5/5/89

B200S ASSY. UPDATES

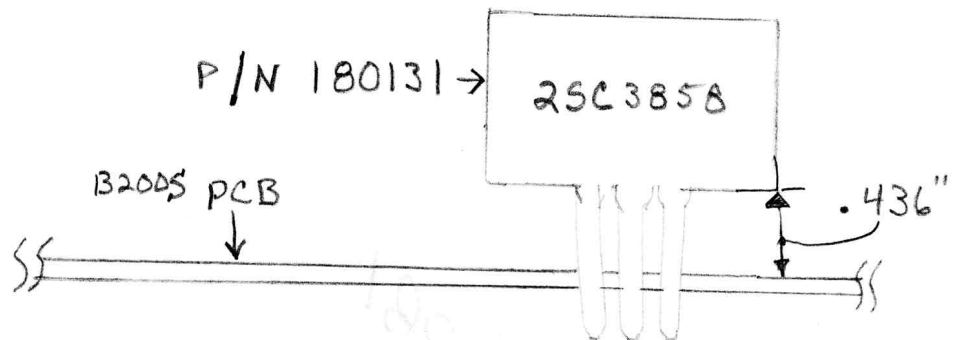
- A.) Position heatsink to PCB at .436" from bottom of transistor to top of PCB.

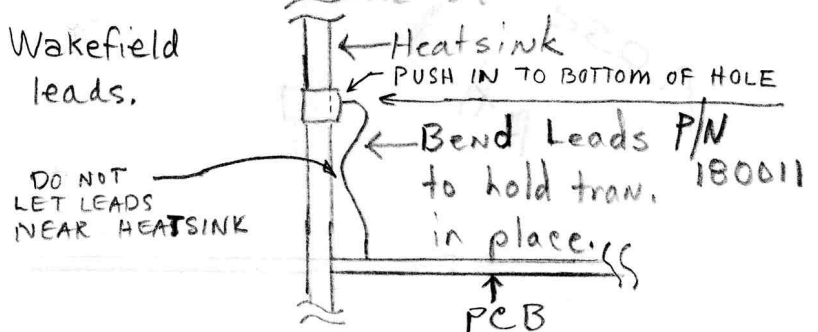
- B.) Bend 8099 transistors so that they will stay in holes in heatsink. Coat Wakefield around transistor head and inside of holes. No Wakefield on transistor leads.

- C.) Apply Wakefield to back of heatsink around mounting screw holes before mounting assembly to chassis base. (5 places) SEE DRAWING # 540601
